Fingerprint Terminal V1.4.0_build220523

Release Note (2022-05-25)

Device Model	Firmware
DS-K1T804AF/AMF/AEF	ACS_1T804A_J1_EN_STD_V1.4.0_build220523
DS-K1T804BF/BMF/BEF	ACS_1T804B_J1_EN_STD_V1.4.0_build220523
DS-K1A802AF/AMF/AEF	ACS_1A802A_J1_EN_STD_V1.4.0_build220523
DS-K1T8003 Series	ACS_1T8000_J1_EN_STD_V1.4.0_build220523
DS-K1A8503 Series	ACS_1A8500_J1_EN_STD_V1.4.0_build220523

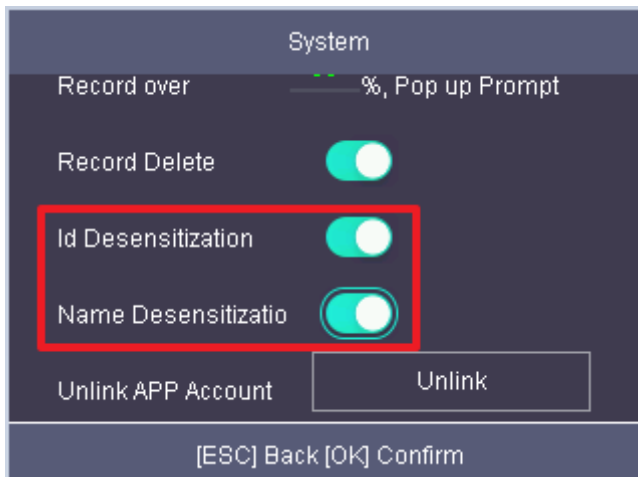
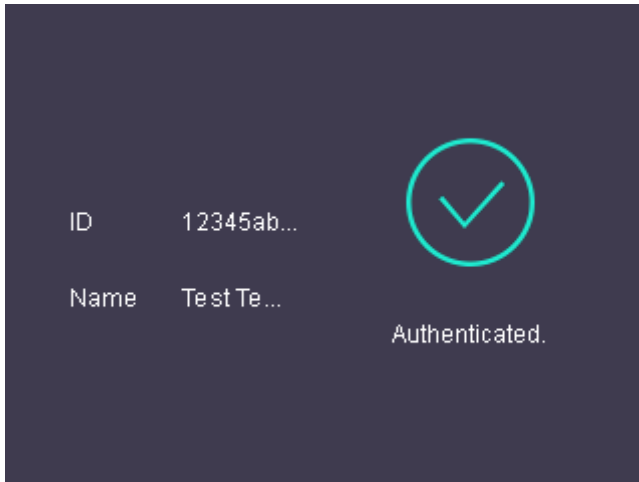
1. ID support letter, ID length less than 32 digit

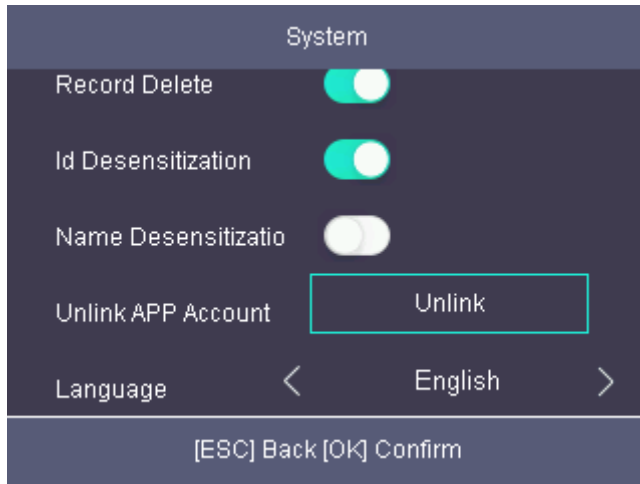
2. Support ID, name desensitization function

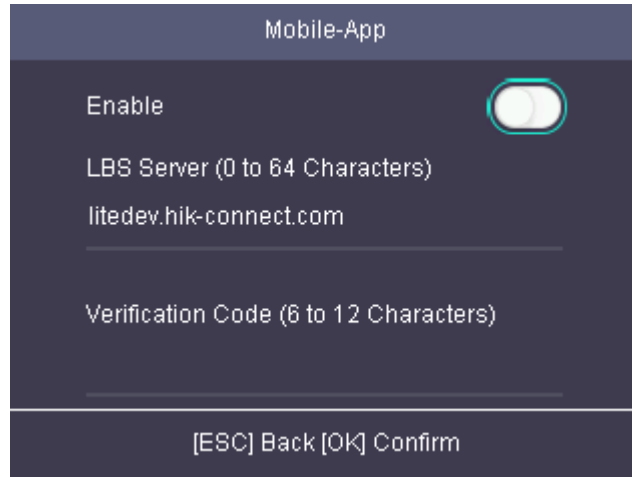
4. Add Hik-Connect menu in device UI Menu → Comm → Mobile App. The function is disabled in default. (For DS-K1T804A, DS-K1T804B, DS-K1T8003 only)
